UNITED STATES ENVIRONMENTAL PROTECTION AGENCY  
REGION 6  
1445 ROSS AVENUE, SUITE 1200  
DALLAS TX 75202-2733

Enclosed please find the Sanitary Survey report for the Firelake Grand Casino Water System (PWS#061020808). A Sanitary Survey is a comprehensive evaluation of the source, pumps and pumping facilities, treatment, distribution (including storage facilities), laboratory facilities, management and operator qualifications at a public water system. The report contains a section entitled "Deficiencies" that lists deficiencies and recommendations, split into the following categories:

# EPA Region 6 Sanitary Survey Form System Information and Contacts

## Firelake Grand Casino Water System Findings

Small Hole next to Screen at  
well K2

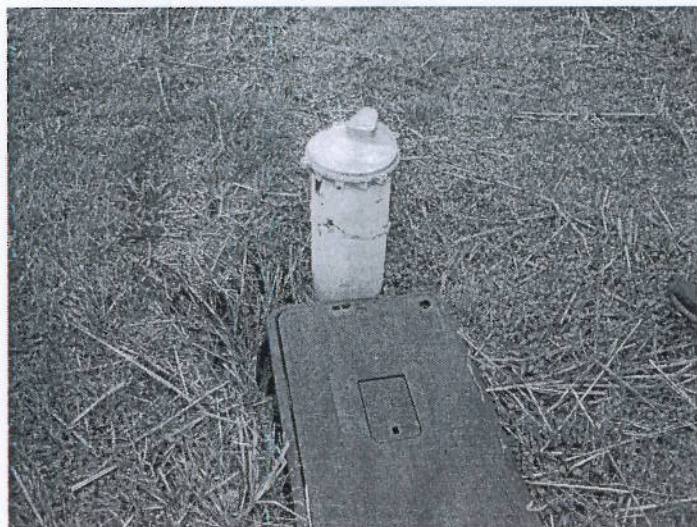
\*\* There is a small hole next to the screen in the well cap that compromises the sanitary seal.

Sources	
All wells	There are no concrete pads around any of the K wells or the North and South Wells
K2 Well	The flow meter and check valve are buried
	The casing does not extend at least 18" above the ground
	There is a small hole next to the vent screen in the well cap
	There is no blow off, no pressure gauge and no raw water sample tap at the well
K3 Well	The flow meter, check valve and isolation valves are buried
	There is no blow off and no raw water tap
	The casing and vent at K3 do not extend at least 18" from the ground and it has flooded in the past (There are plans to raise it and convert it to a vertical well)
	The well casing cap had been damaged and was broken into several pieces, therefore the sanitary seal was not intact.
K4	The well is under the influence of surface water
K5	The well is under the influence of surface water
K6	The well is under the influence of surface water
South Well	The well has no flow meter, pressure gauge, blow off, raw water sample tap or check valve.

Well K3 showing distance to  
River and height of casing

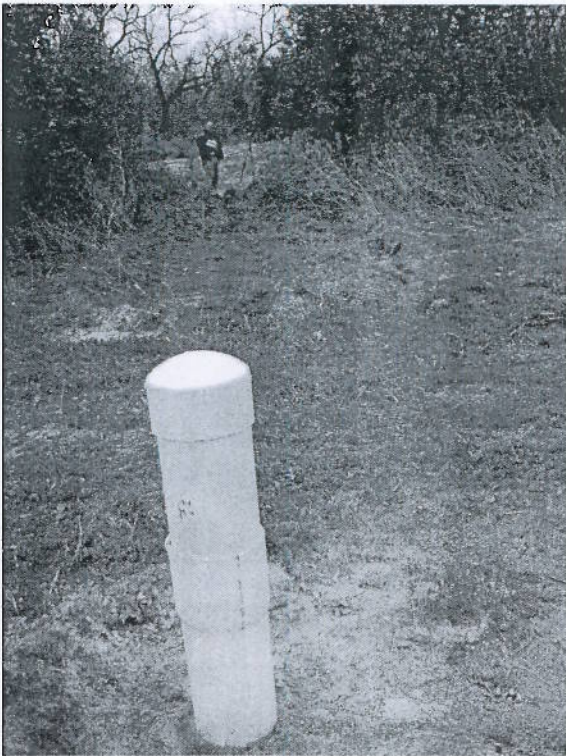
\* There are plans to convert the well to vertical well and raise the casing and vent. because the well has flooded in the past.

\*\* The well cap is broken.

Well K3 showing broken well cap

South well showing gap where rope enters the well head

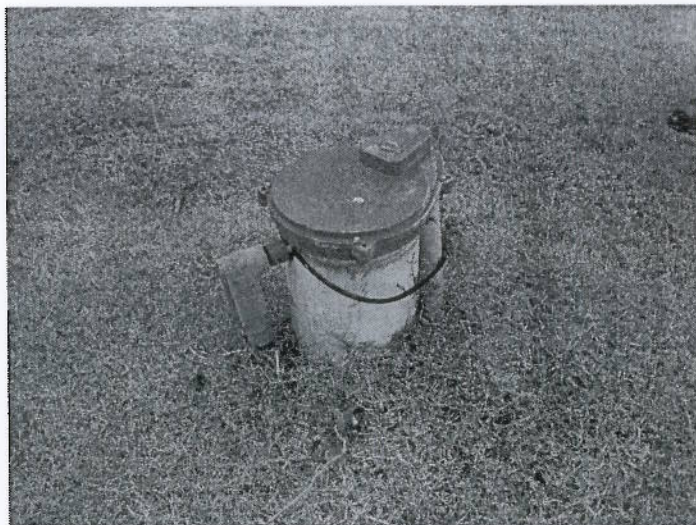
\* There is a gap in the well where a rope enters the well casing, compromising the sanitary seal.

There is a gap in the well head where a rope enters the casing. This compromises the sanitary seal.
	The well casing and vent do not extend at least 18" above the ground
North Well	The well has no flow meter, pressure gauge, blow off, raw water sample tap or check valve.
	There is an abandoned well within 20' of the north well (said to be only 1 or 2 feet deep)
	The well casing and vent do not extend at least 18" above the ground
	There are openings in both of the electrical conduits going into the well.
Well 3	The well vent is not 18" above the ground, is not turned over and does not have a 24 mesh screen.
	The well 3 pad does not extend 3 feet from the well casing in all directions.
	Well 3 does not have a blow off
	There is a gap where the electrical conduit is connected to the well casing cap that compromises the sanitary seal.
Well 4	The concrete pad at well 4 does not extend 3 feet in all

North well showing gap where  
electrical lines enter on one side

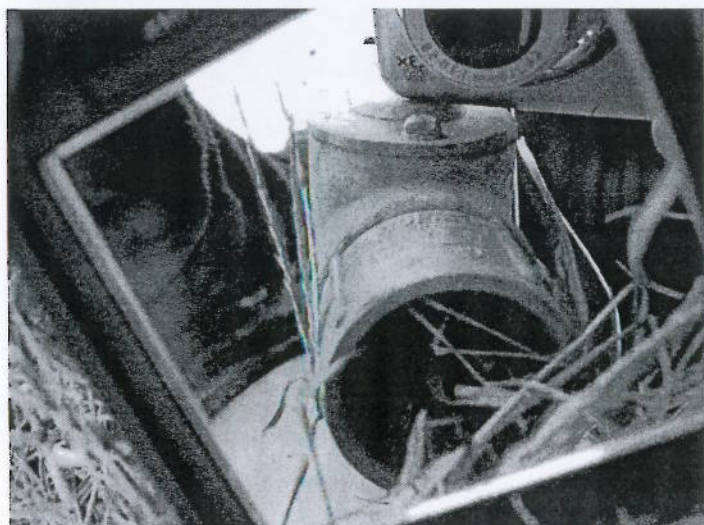
\* There are gaps on both sides of the well head where electrical conduit enters.

North well showing gap where  
electrical lines enter the other  
side

North well showing nearby  
abandoned well

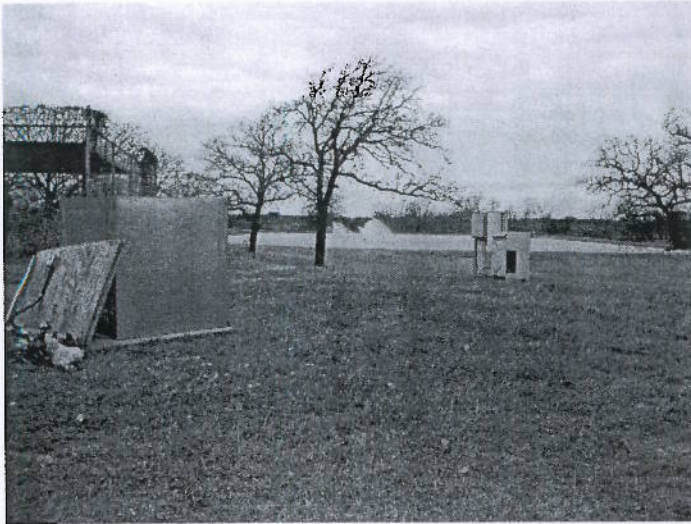
\*\* There is an abandoned well within 20' of the well head (The abandoned well is thought to be only 1 or 2 feet deep). The well is adjacent to a run off pond used for geothermal heating/cooling.

Well 3 well house showing  
proximity to waste water pond

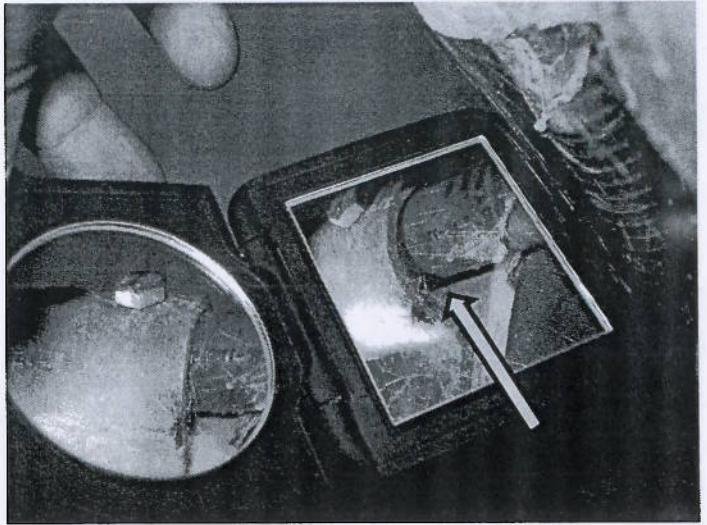
\*\*\*\* There is a treated waste water pond about 400' from the well.

Sources	
Well 3 and Well 4	The wells are within 400 feet of a treated wastewater pond. (Plans for future wells should be submitted to EPA prior to construction to prevent similar situations.)
Batch Plant East Well	There is no screen on the Batch Plant East well air relief valve, however the well is inactive. The screen needs to be fixed before activation.
	The well cap is loose on the Batch Plant East well (inactive well needs to be corrected before being activated). It also has a hole where the electrical line enters.
Management	There is no emergency plan for the PWS (There was no previous requirement for an emergency plan but this survey will change the water system classification to <i>community</i> ).
Storage	There is no gasket on the raw/gray or finished water 20K gallon storage tank hatch lids.

Well 3 gap where electrical line  
enters well head

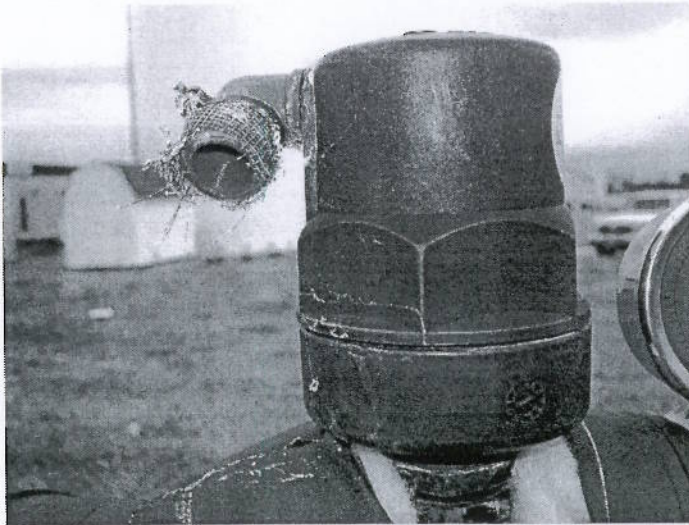
\*\* There is a gap where the electrical line enters the well head.

Batch Plant East Well Air relief valve unscreened

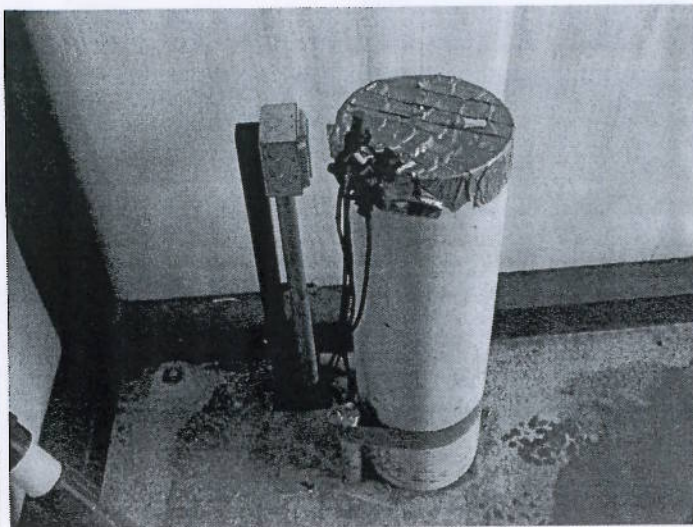
\* There is no screen on the air relief valve

Batch Plant West Well showing duct tape cap, hole where electrical lines enter and lack of electrical conduit

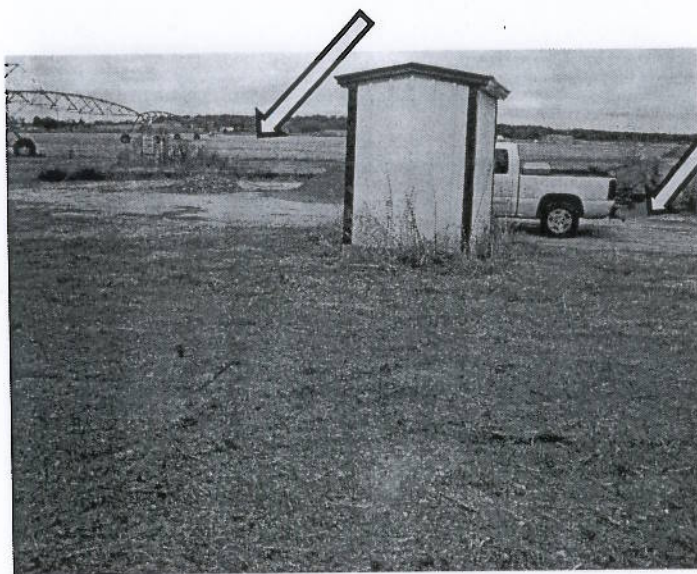
\* The electrical line serving the well is not incased in conduit.

\* The well head is missing the cap and is sealed with duct tape.

directions.
	Well 4 was not locked.
Batch Plant West Well	There is no screen on the Batch Plant West well air relief valve
	The electrical line connected to the Batch Plant West well is not in a conduit.
	The Batch Plant West well does not have a proper well cap (duct tape)
	There is no vent on the Batch Plant West well head.
	The concrete pad does not extend 3 feet in all directions from the edge of the casing.
Roadway well	The roadway well has no flow meter, blow off, raw water sample tap or pressure gauge.
	The roadway well is below grade, in a vault
Storage	
Finished Water Storage tank (20K gallon tank)	The finished water storage tank was put into service in 2006/2007 and has never been inspected/cleaned.

Roadway well vault in Road

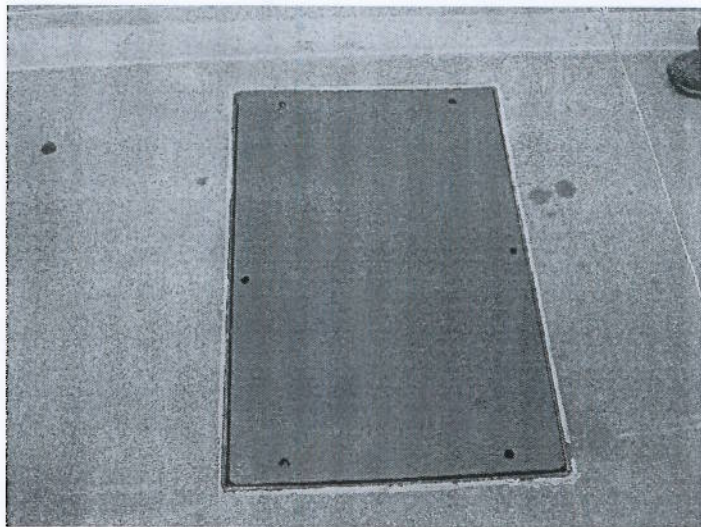
\* The well is in a vault in the middle of a roadway.

\* Because the well is in a vault, the vent compromises the sanitary seal.

\*\* The well is located in a roadway and within 60 feet from the geothermal water pond.
